ENCLOSURE 4
SHEARON HARRIS NUCLEAR POWER PLANT
NRC DOCKET NO. 50-400/LICENSE NO. NPF-63
REQUEST FOR LICENSE AMENDMENT
PROPOSED SPECIFIC TIME LIMIT TO PLACE CHANNEL IN BYPASS

ENCLOSURE 5
SHEARON HARRIS NUCLEAR POWER PLANT
NRC DOCKET NO. 50-400/LICENSE NO. NPF-63
REQUEST FOR LICENSE AMENDMENT
PROPOSED SPECIFIC TIME LIMIT TO PLACE CHANNEL IN BYPASS

Attachment 1
Request for License Amendment
Diesel Fuel Oil System Pressure Testing
Additional Information

Serial: HNP-97-045
Page 1 of 2

DIESEL FUEL OIL SYSTEM SCHEMATIC
 PIPING EXEMPT FROM 110% PRESSURE TEST (TYPICAL)

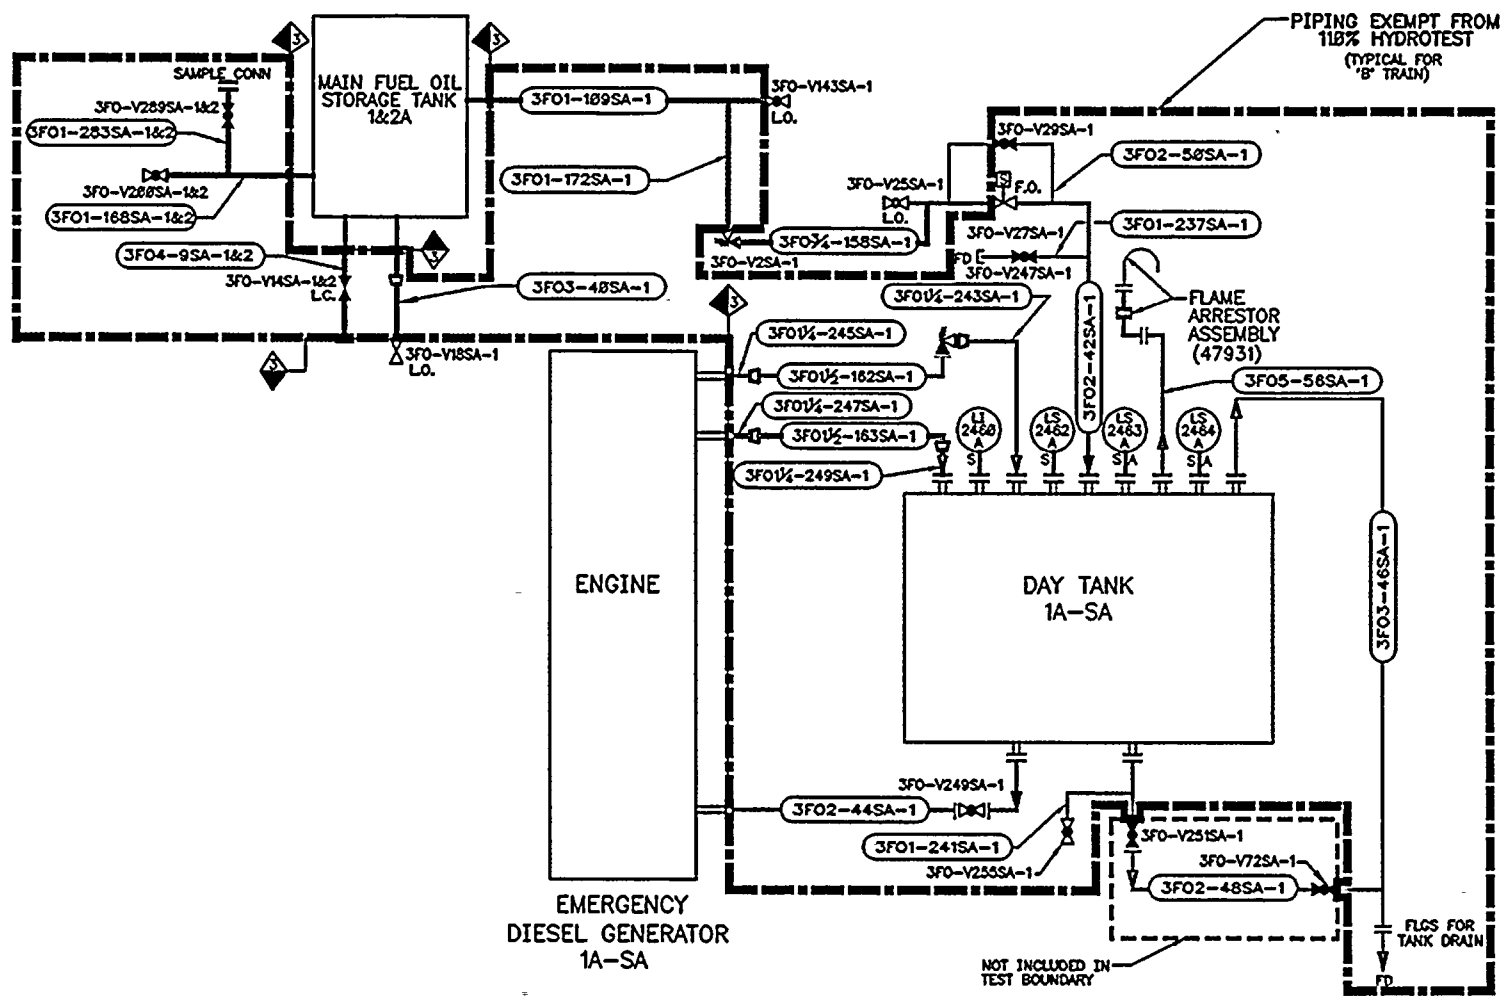
Subarticle IWD-5223, Item (b) states that "In the case of atmospheric storage tanks, the hydrostatic head, developed with the tank filled to its design capacity, shall be acceptable as the test pressure." The Fuel Oil Day Tanks 1A-SA and 1B-SB are atmospheric tanks and are therefore addressed by this section and would not require a 110% pressure test. The day tanks are above ground and can be visually inspected for leaks during normal operation.
(Please reference the "purple" color-coded portions on Attachment 2 to this letter)

Subarticle IWD-5223, Item (c) states that "For the purpose of the test, open ended portions of suction or drain lines from a storage tank extending to the first shutoff valve shall be considered as an extension of the storage tank." Several fuel oil lines extending from the main fuel oil storage tanks and the day tanks to the first shutoff valve are addressed by this section and therefore would not require a 110% pressure test. These lines can also be visually inspected during normal operation. Observation of adequate level in each of the tanks will ensure that the piping is full of oil during visual inspections.

3FO1-109SA-1	3FO1-168SA-1&2
3FO1-283SA-1&2	3FO4-9SA-1&2
3FO3-40SA-1	3FO2-44SA-1 (between isolation valve and day tank)
3FO2-42SA-1	3FO1-241SA-1
3FO1-237SA-1	3FO1-172SA-1
3FO2-50SA-1	3FO2-48SA-1 (between isolation valve and day tank)

Subarticle IWD-5223, Item (e) states that "Open ended vent and drain lines from components extending beyond the last shutoff valve and open ended safety and relief valve discharge lines shall be exempt from the hydrostatic test." The vent, drain and relief valve lines associated with the day tanks are addressed by this section and therefore should be exempted from the 110% hydrostatic test.

3FO3-46SA-1
3FO5-56SA-1
3FO1 ¼-243SA-1

3. Table IWD-2500-1, Item D2.10, Note (1) states that "The system boundary extends up to and including the first normally closed valve or valve capable of automatic closure as required to perform the safety-related system function." Since the day tank floor drain isolation valves (3FO-V251SA-1 and 3FO-V72SA-1) are normally closed, line 3FO2-48SA-1 will not be included in the test boundary.

3FO2-48SA-1

PIPING EXEMPT FROM 110% HYDROTEST (TYPICAL FOR 'B' TRAIN)

NOT INCLUDED IN TEST BOUNDARY
